Final Environmental Impact Report (Final EIR)

Los Angeles International Airport (LAX) Bradley West Project

Responses to Comments and Corrections and Additions to the Draft EIR

September 2009

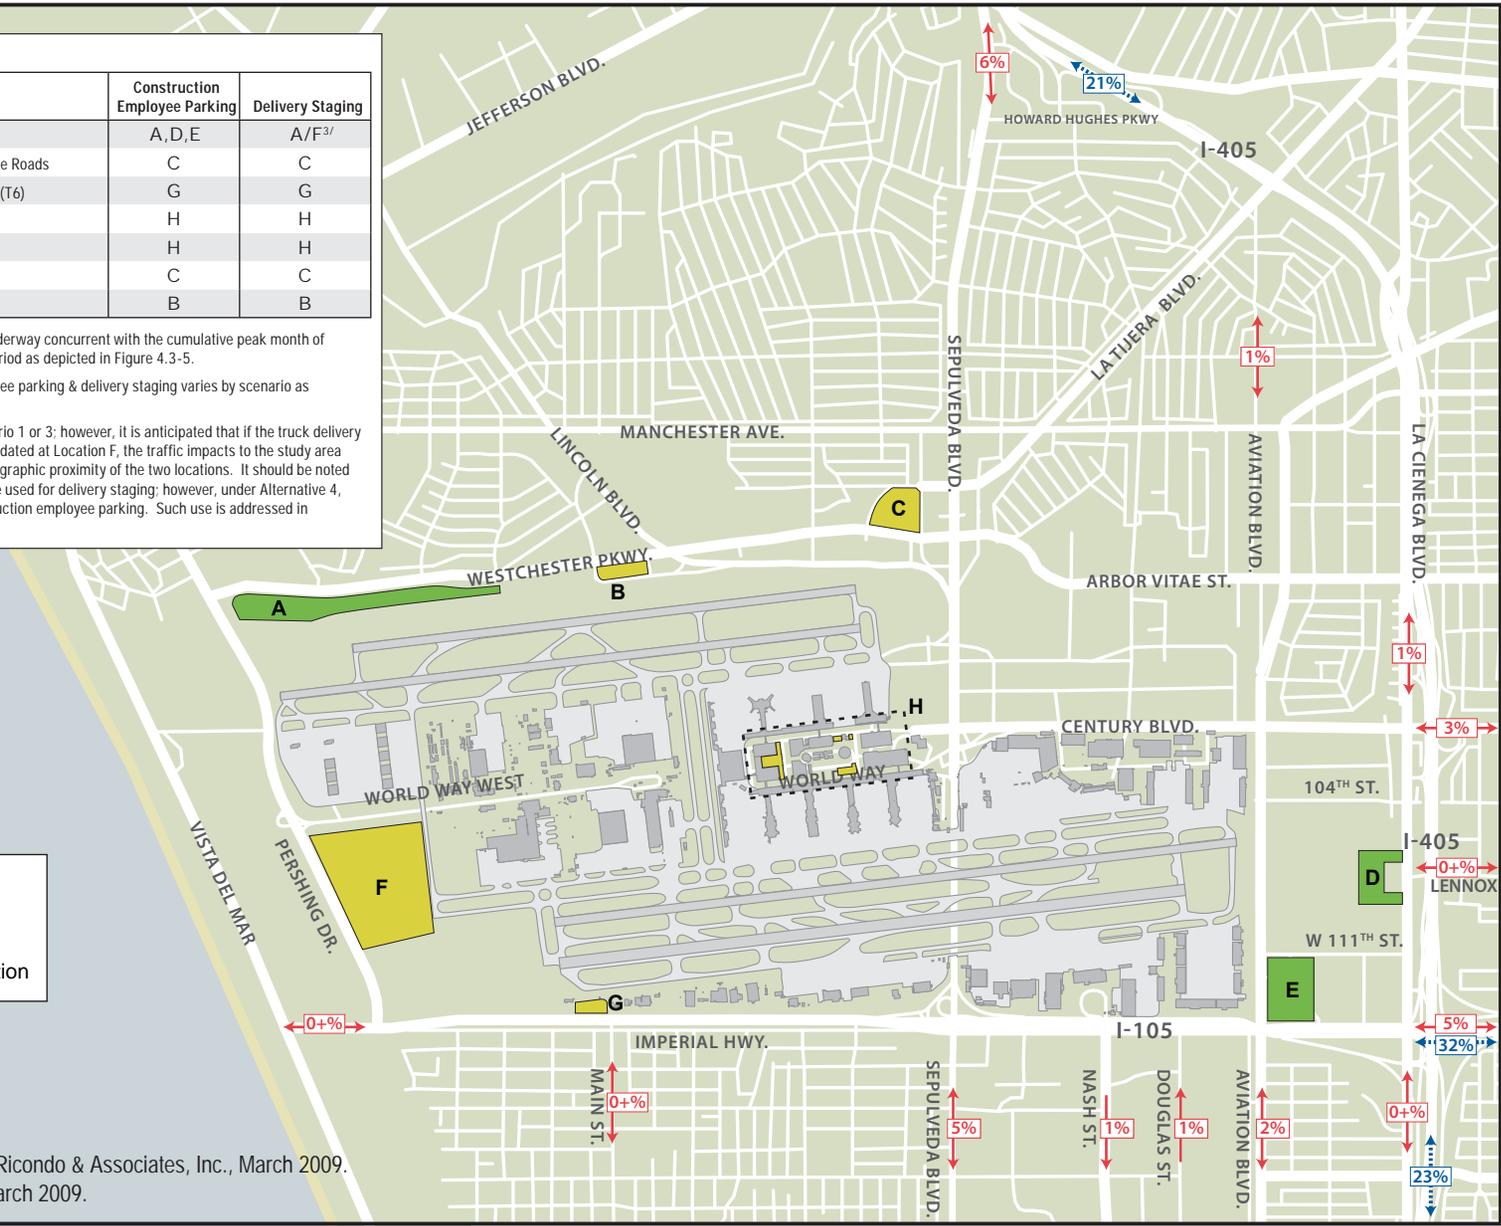
Comment: Please explain the discrepancy between: (1) Figure 4.3-6, which indicates that the West Construction Staging Area (referred to as location F in Figure 4.3-6) is one of the parking and staging locations for the Bradley West Project, and (2) the analysis in Chapter 4.3 of the DEIR, which only discusses the Northwest Construction Parking/Staging Area, Southeast Construction Parking/Staging Area, and East Contractor Employee Parking Area.

14. Figure 4.3-6 on page 4-207 of the Draft EIR has been revised to clarify that the West Construction Staging Area would only be used for construction staging under the proposed project. Please see the following revised figure.

3/ Location F was not specifically analyzed as part of Scenario 1 or 3; however, it is anticipated that if the truck delivery volumes accessing Location A for staging were accommodated at Location F, the traffic impacts to the study area network would generally be the same given the close geographic proximity of the two locations. It should be noted that under the proposed project, Location F would only be used for delivery staging; however, under Alternative 4, Location F would be used for delivery staging and construction employee parking. Such use is addressed in Section 6.4.3.4.
